RESPONSE TO SUBMISSIONS

CURL CURL NORTH PUBLIC SCHOOL
SSD 17_8310

10 APRIL 2018
PREPARED FOR NSW DEPARTMENT OF EDUCATION

Figure 1 – Comparison of Original Site Plan (As Exhibited) and Amended Site Plan

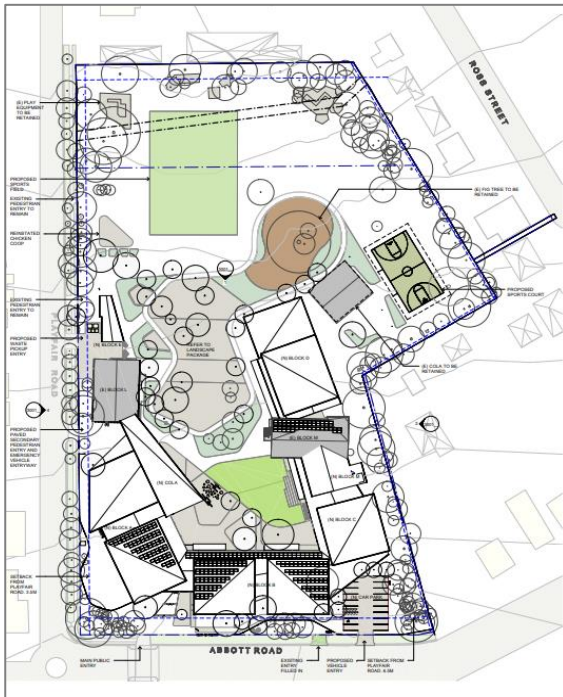
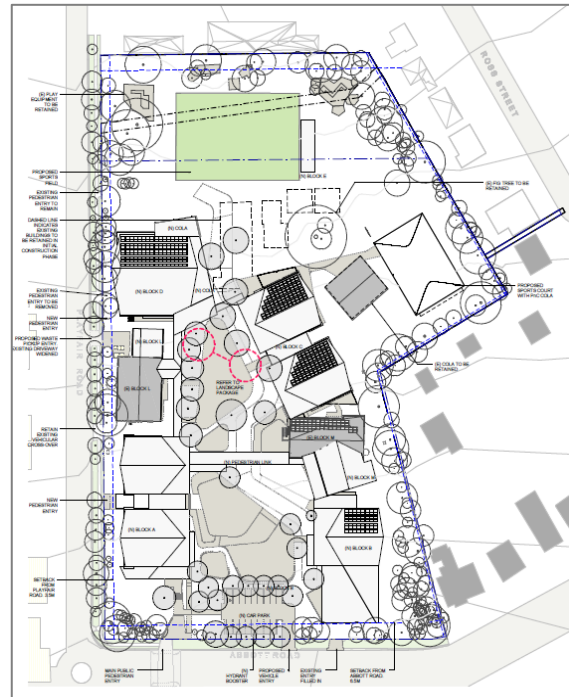
A visual comparison of the original scheme (exhibited from 31 August 2017 until 16 October 2017) and the amended proposal is provided below in **Figure 1 (Picture 1 and Picture 2)**. A 3D perspective of the amended proposal is provided in **Figure 2**.

Figure 3 – Maximum Height of Building Location

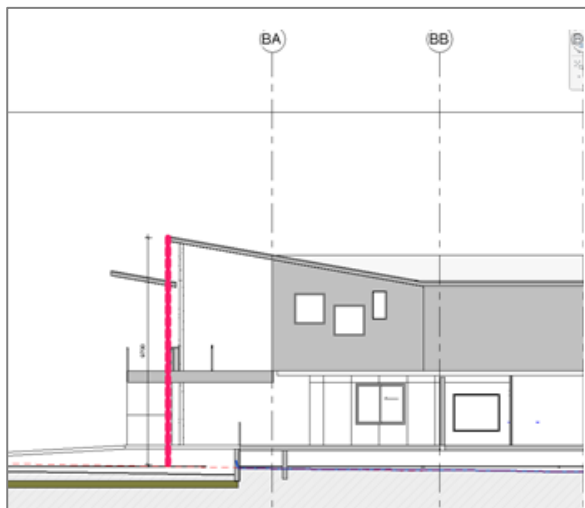
Pursuant to Clause 4.3 of the WLEP a maximum height limit of 8.5m applies to the site. The maximum height of the amended School proposal is 9.8m, which affects Block B at the area identified in **Figure 3**. Other parts of the proposed School buildings also slightly exceed the maximum building height control.

Figure 4 – Winter Solstice 9am Comparison

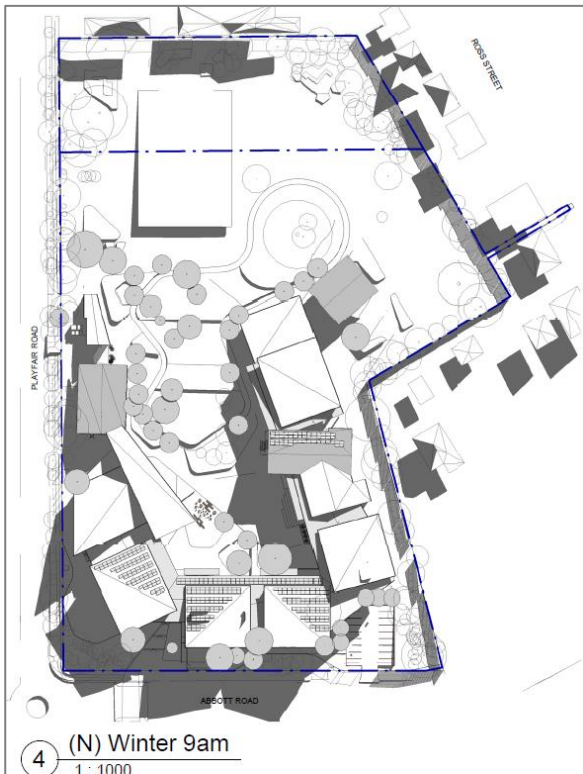
- At 9am overshadowing of the footpath and Abbott Road is reduced. A small section of the footpath will be overshadowed but much less than the original proposal.
- At midday overshadowing of the footpath and Abbott Road is reduced. A small section of the footpath will be overshadowed but much less than the original proposal. Internal overshadowing of the school grounds is also reduced.
- At 3pm there is minimal overshadowing of the footpath along Abbott Road. The amended proposal reduces the overshadowing on the residential properties to the east. In fact, the amended proposal has a similar level of shadowing when compared to the existing development. the overshadowing is primarily caused by the existing timber fence and vegetation, which is being retained.
